Technical Memorandum

SUBJECT: Review of Badgerjack Resource Holdings, L.P. Simsboro Aquifer Evaluation Report

DATE: July 3, 2023

Figure 1. Proposed Badgerjack Resource Holdings, L.P. Well Location Map

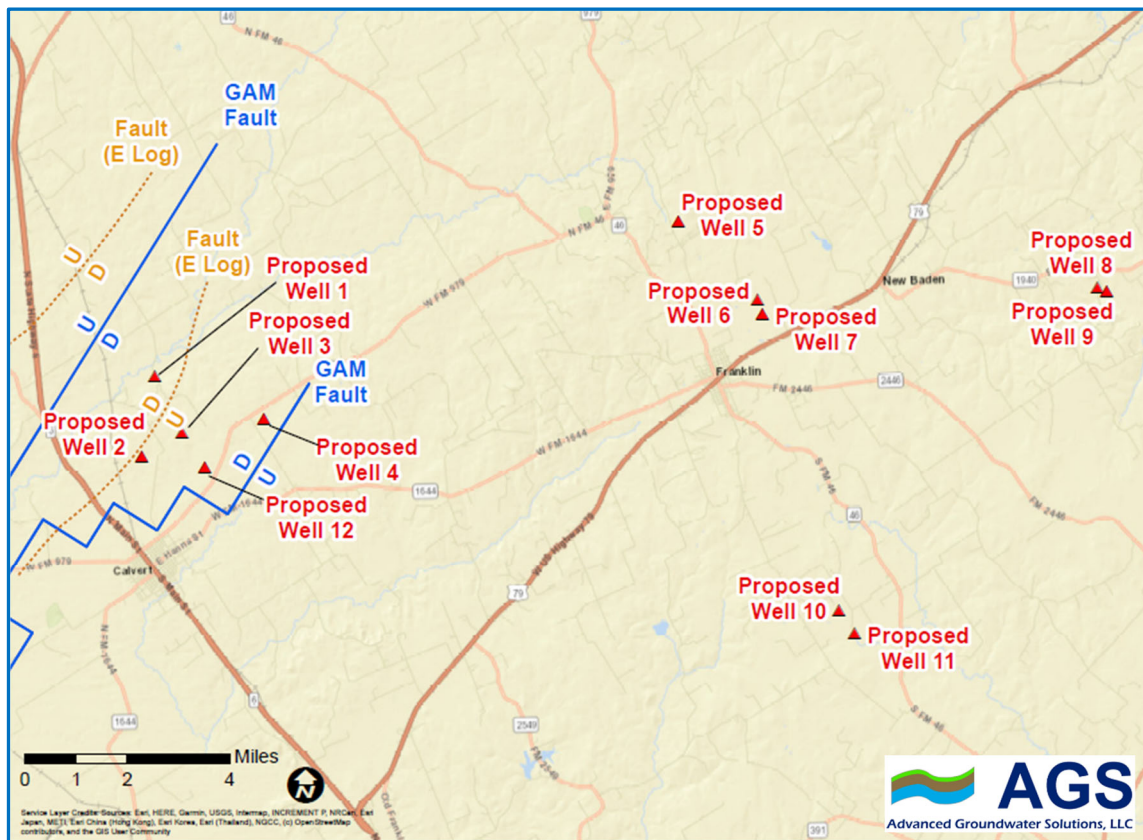
As shown on Figure 1, proposed Badgerjack Wells 1 through 4 and Well 12 are located in a down dropped area of the Simsboro Aquifer that is between two GAM estimated faults. GWC and AGS have mapped the Simsboro Aquifer using available electric log data in the vicinity of this geologic feature, which is known as a graben. The estimated extent of the faulting and graben mapped by GWC and AGS is shown on Figure 1 as a dashed line. Based on the electric log data reviewed, proposed Badgerjack Well 1 is the only proposed Badgerjack well located within the graben and proposed Wells 2, 3, 4 and 12 are not estimated to be located in this geologic feature. There is a large difference between the GAM and electric log estimated top and bottom of the Simsboro Aquifer at proposed Badgerjack Well 1. Proposed Wells 2, 3, 4 and 12 have better agreement of the tops / bottoms of the Simsboro Aquifer between the GAM and electric log datasets.

Figure 2. AGS This Analytical Simulated Drawdown After Proposed Badgerjack Pumping of 16,421 ac-ft/yr for 1-Year (TGI Hydraulic Properties)

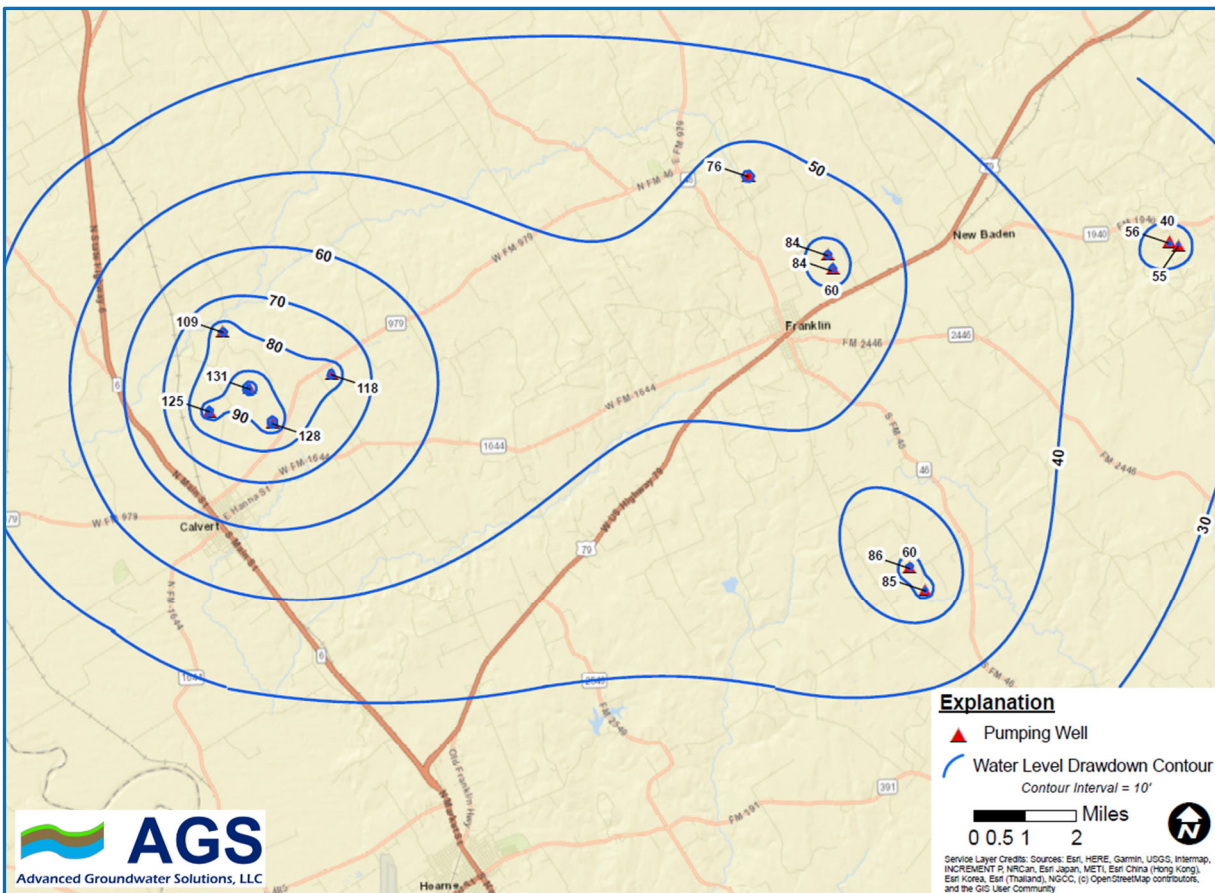
There is an increased density of contours near the proposed Badgerjack wells using the AGS approach and we think these are more appropriate estimates of “near well” drawdown. However, there are many factors that will determine the actual drawdown near the well during pumping, and therefore, these differences are assumed to be minor for the purposes of the AER. Figures 2 and 3 below show the estimated AGS analytical modeling drawdown contours that result from pumping 16,421 ac-ft/yr for 1-year and 10-years, respectively.

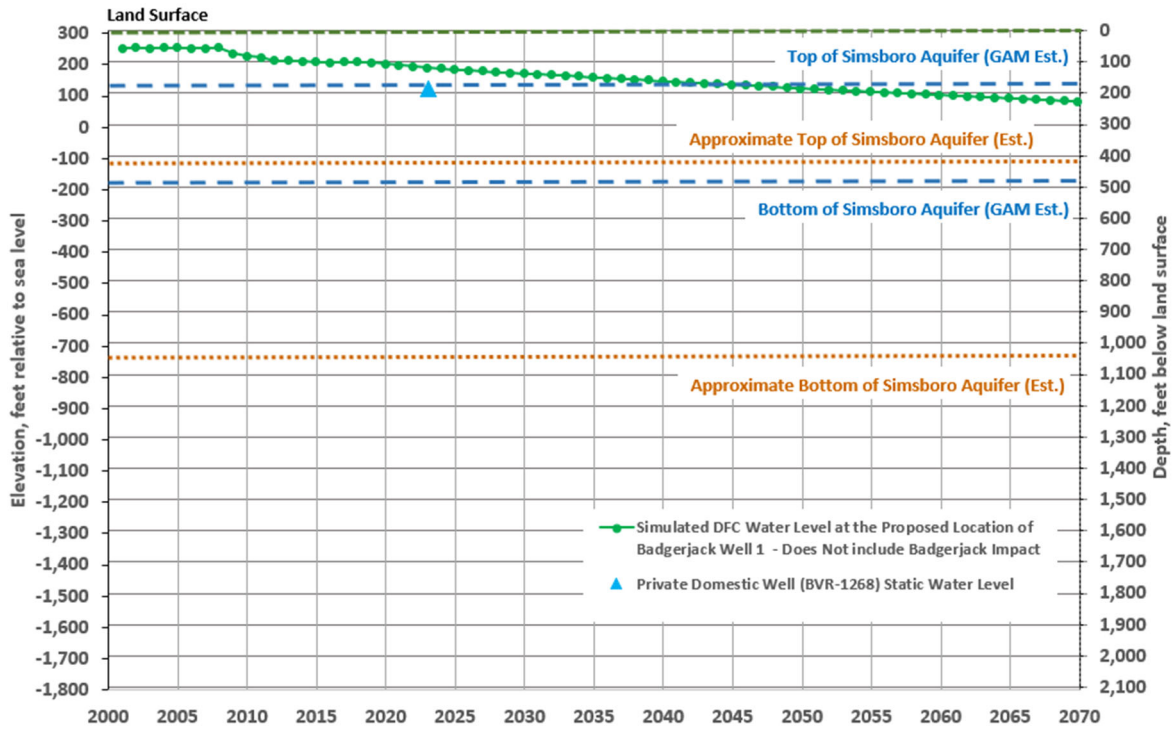
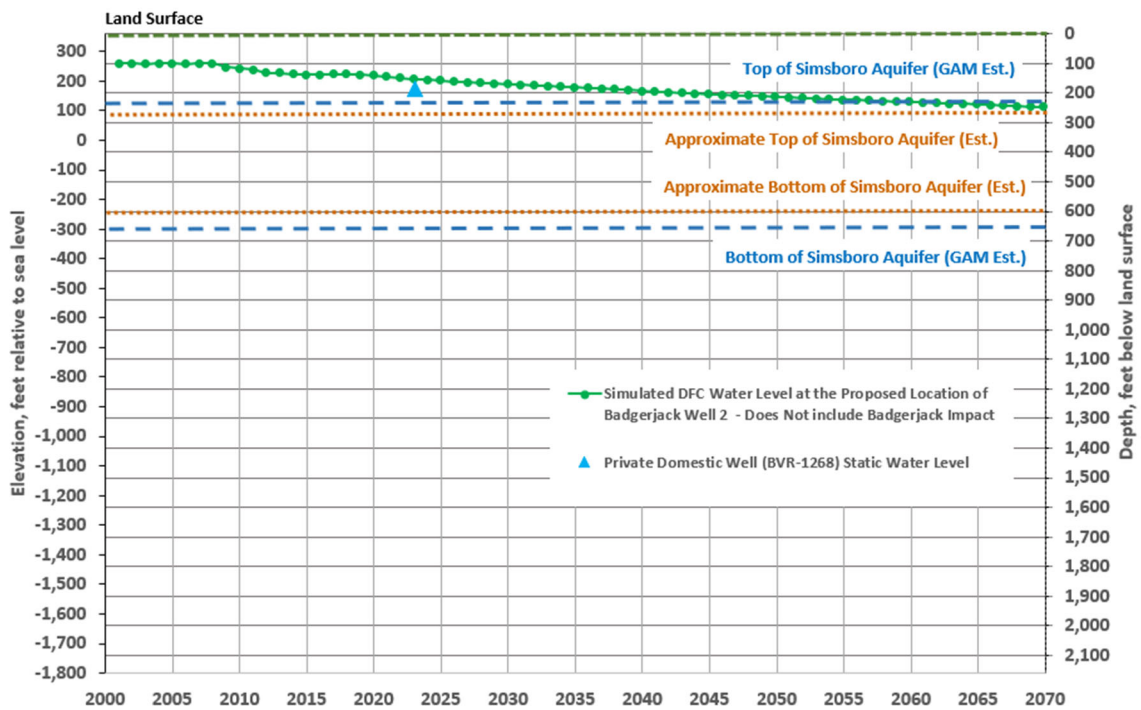
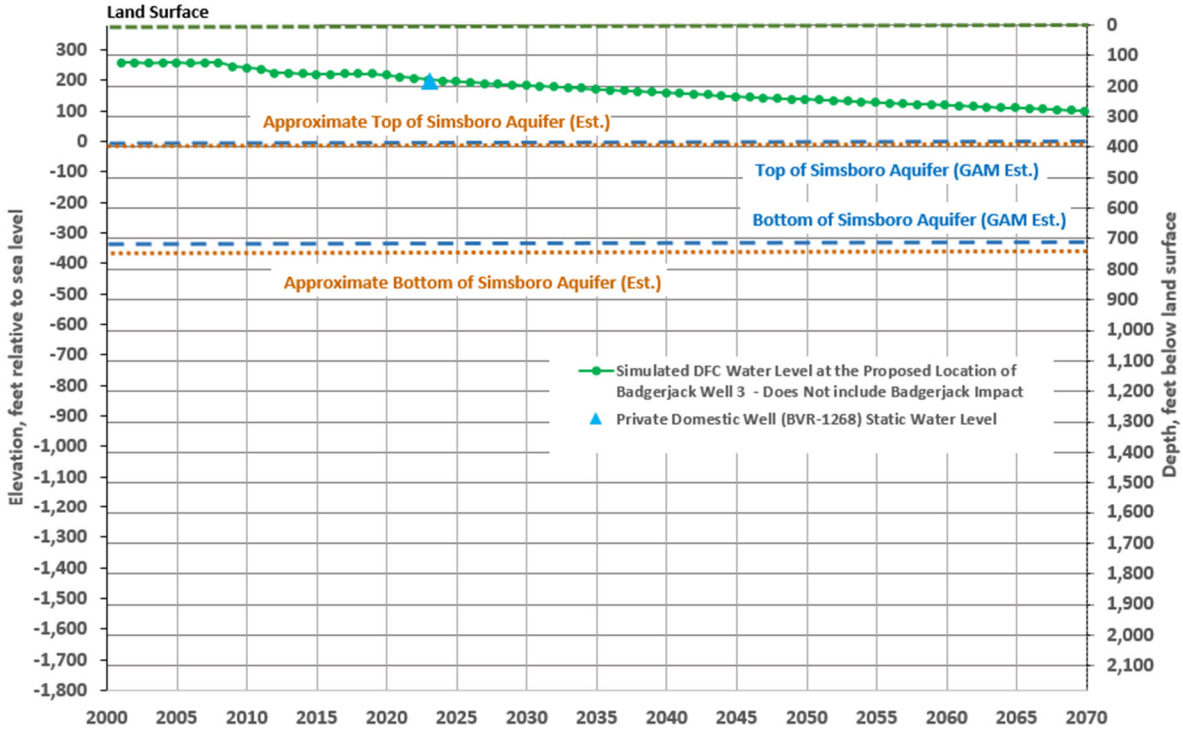
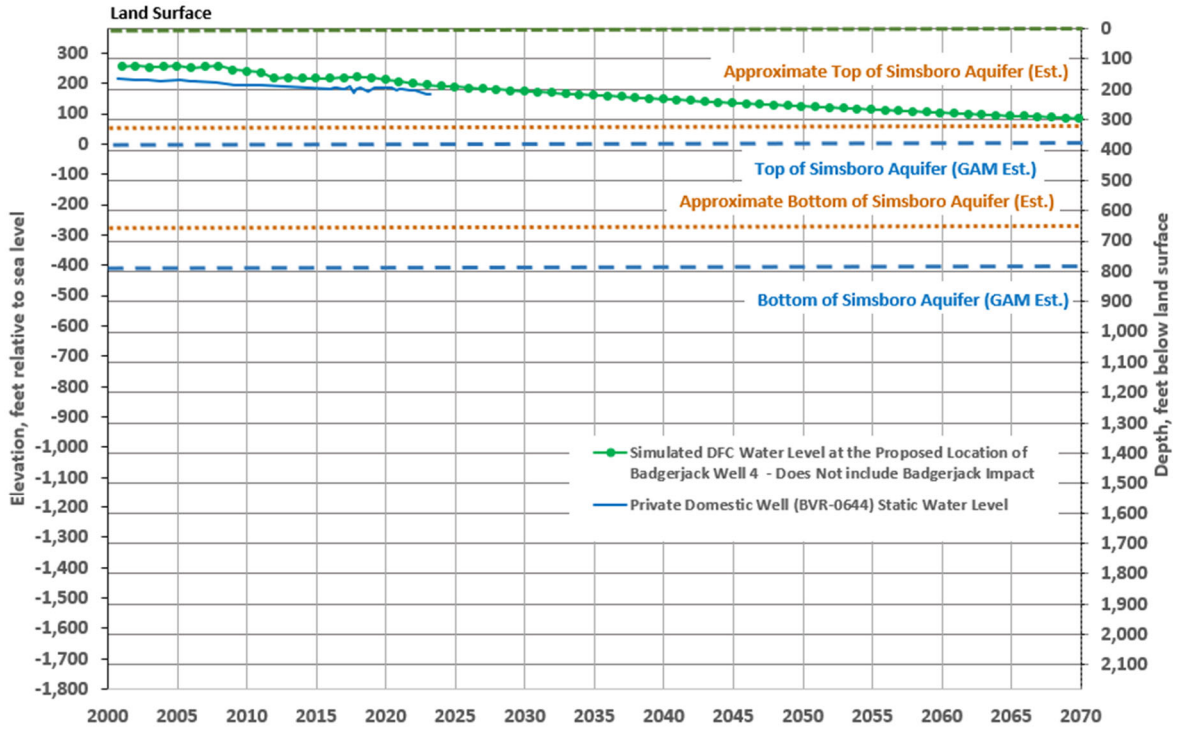
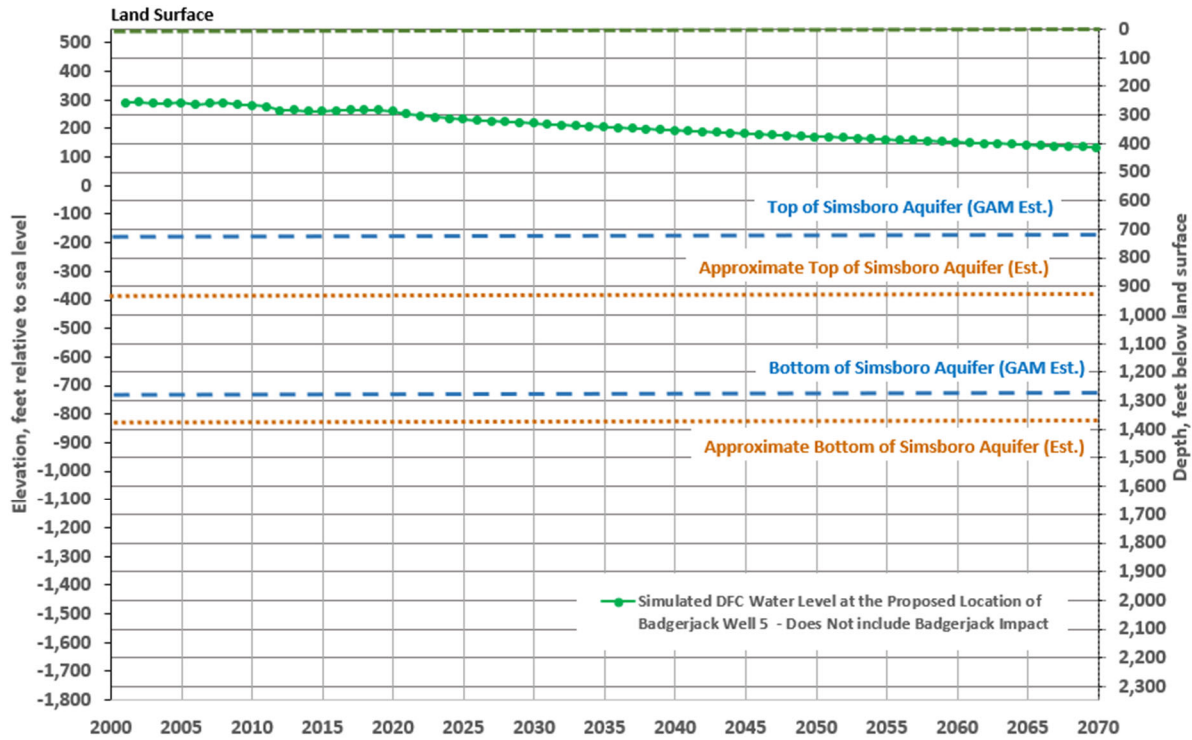
Figures 4 through 8 and Figure 15, attached to this memorandum, show the estimated tops and bottoms of the Simsboro Aquifer based on a localized review of available geophysical logs by Ground Water Consultants (GWC) and AGS. The GAM estimated tops and bottoms of the Simsboro Aquifer are also shown on these figures as well as Figures 9 - 14. There is some offset between depth to the top and bottom of the Simsboro Aquifer between the GAM and geophysical log datasets, but the differences appear to be within reason at most proposed Badgerjack well locations.
